CRITICAL MEASURE BCA COMPLIANCE ASSESSMENT

To:	Hi Noon Ski Club Thredbo	Date:	4 February 2025
Attention:	Ziggi Krpan	Project Ref:	3430
From:	James Alexander	Revision:	Rev F FINAL
Project:	Hi Noon Ski Club Thredbo		
Purpose:	BCA Compliance Assessment of proposed upgrades to sanitary compartment and conversion of existing storage room to SOU

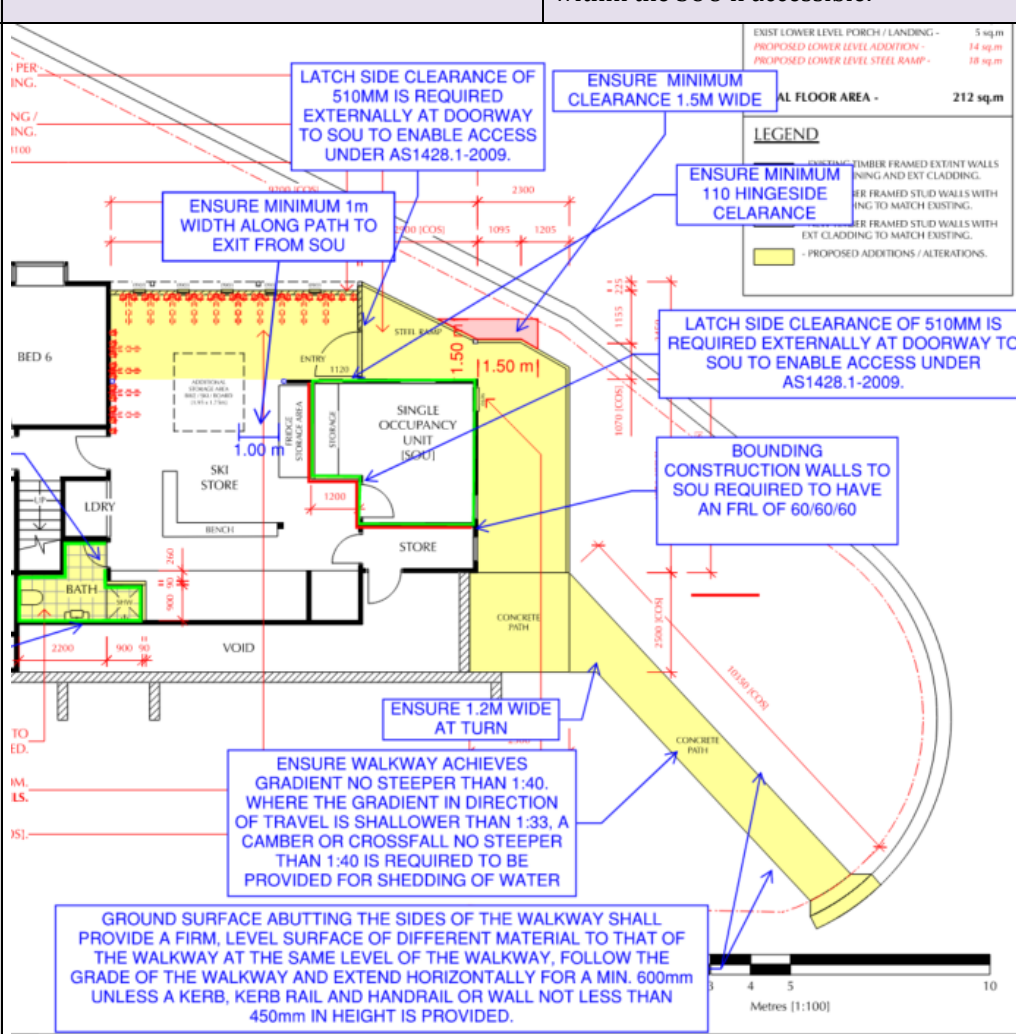
BCA CLAUSE	COMPLIANCE ISSUE	DESIGN RECOMMENDATION
	 <p>Figure 1 - Fire resisting requirements</p>	
<p>BCA CLAUSE D2D3 NUMBER OF EXITS</p> <p>BCA CLAUSE D2D5 - EXIT TRAVEL DISTANCES</p>	<p>In a building under 25m, one exit is required to be provided per level, the distance of travel to an exit or point of choice is required to be within 6m on the upper level and 20m on the ground floor level.</p>	<p>The sanitary compartment and proposed SOU are located within 20m of an exit.</p>
<p>BCA CLAUSE D2D7 - HEIGHTS OF EXITS, PATHS OF TRAVEL TO EXITS AND DOORWAYS</p> <p>BCA CLAUSE D2D8 WIDTH OF EXITS AND PATHS OF TRAVEL TO EXITS</p>	<p>In a required exit or path of travel to an exit —</p> <ul style="list-style-type: none"> • The unobstructed height throughout must be not less than 2m, except the unobstructed height of any doorway may be reduced to not less than 1980mm. • The unobstructed width of each exit or path of travel to an exit, except for doorways, must be not less than 1m. 	<p>The reduced height is located over the WC and therefore not considered a path of travel to an exit. The reduced ceiling height will however need to be addressed under F5D2.</p>  <p>Figure 2 - raked ceiling over WC is less than 2.1m over the WC.</p>

BCA CLAUSE F5D2 – HEIGHTS OF ROOMS AND OTHER SPACES	A minimum of 2.1m ceiling height is required to be provided in accordance with BCA Clause F5D2 to the subject sanitary compartment.	The extension of the compartment must include a 2.1m head height. The low head height under the stair will need to be addressed via a performance solution.
